**Staff Analysis of Proposed Amendment to the
Dane County Water Quality Plan,
Removing a Prior Condition of Approval
in the Waunakee Urban Service Area**

Proposed Amendment to the Dane County Water Quality Plan,
Removing a Prior Condition of
Approval in the Waunakee Urban
Service Area

Map 6 – Geotechnical Soils Investigation

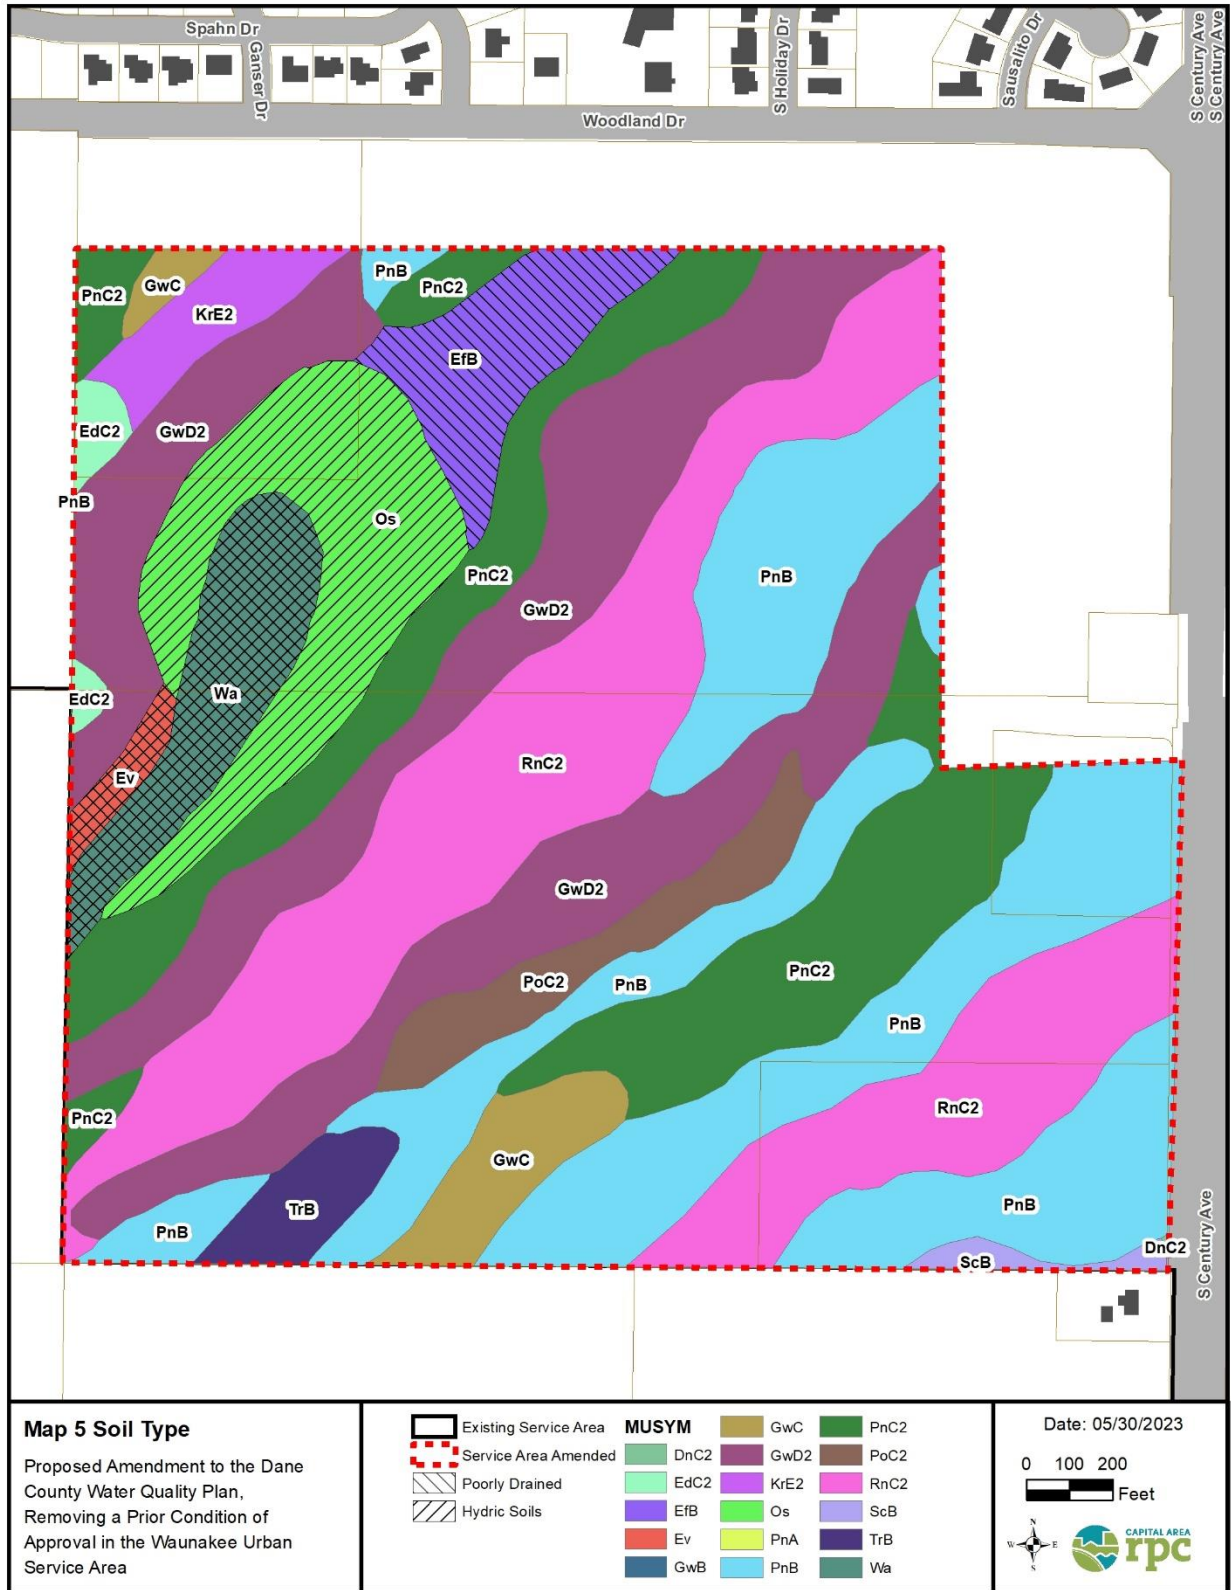
Soil evaluations were conducted by Vierbicher and CGC to determine subsurface conditions. A total of 71 soil test pits were conducted within the amendment area and adjacent service area (see Map 6). Map 6 indicates that 29 (~41%) of the test pits contain soil conditions considered “good” for infiltration, which was defined by the applicant as having a layer of soil with an infiltration capacity of 0.5 inch/hour or greater. Most of these locations, however, were located on an upslope and the effective infiltration rate was no more than 0.5 inch/hour. Groundwater and redox soils indicating seasonal high groundwater were also observed in areas.

Map 7 – Proposed Stormwater Management

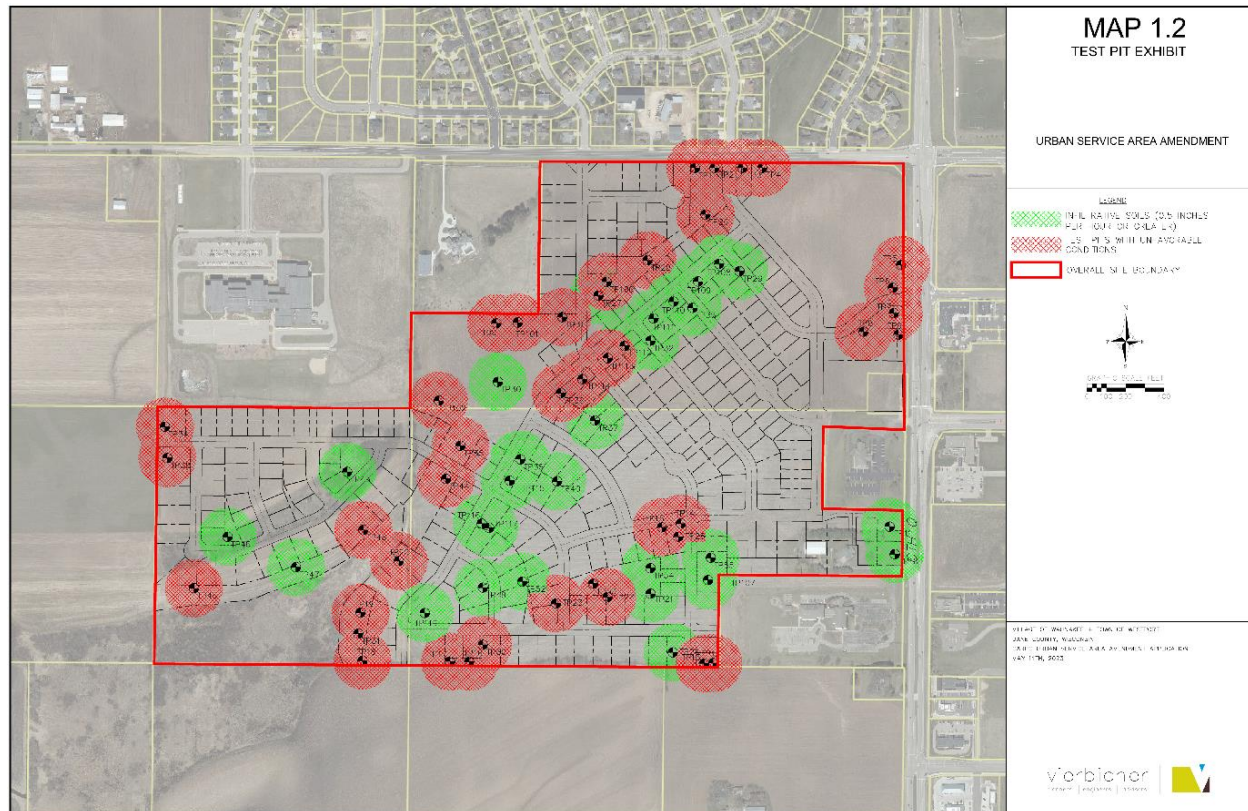
The preliminary SWMP submitted with the current application achieved infiltration of 55% of the additional post-development runoff volume from the 100-year storm (10.59 ac-ft), approximately 8.62 ac-ft short of meeting the condition (1)(e) requirement to achieve 100% volume control for the 100-year storm. The plan achieved 89.3% infiltration of the predevelopment infiltration volume for the average annual rainfall, just shy of the Dane County requirement to infiltrate 90% of the average annual rainfall.

After review by CARPC staff and the Village stormwater reviewer, suggestions were made to increase the efficiency of the system and achieve an increased level of infiltration. Additionally, the development team was asked to consider offsite infiltration as a way of meeting the volume control standard; while this was considered, it was determined by the Developer to not be feasible. Considering the feedback provided, the Village submitted a revised stormwater management plan, dated May 24, 2023, as an amendment to the application. In the revised plan, infiltration of 76% of the additional post-development runoff volume from the 100-year storm (14.82 ac-ft) was achieved, approximately 4.77 ac-ft short of meeting the condition (1)(e) requirement. The revised plan achieved 93.3% infiltration of the predevelopment infiltration volume for the average annual rainfall. Currently, the area dedicated to infiltration facilities is approximately 2.7% of the Kilkenny Farms-West plat area (excluding the area of commercial development which will be required to provide their own stormwater controls). In accordance with Ch. 14.12(2)(e)(3) of the Dane County ordinance, the minimum area required to be dedicated to meeting the infiltration goal is 2% of the site.

It appears the development team has made reasonable accommodations to meet the volume control standard to the maximum extent possible, but still is unable to achieve 100% volume control for the 100-year storm in accordance with the original condition (1)(e).
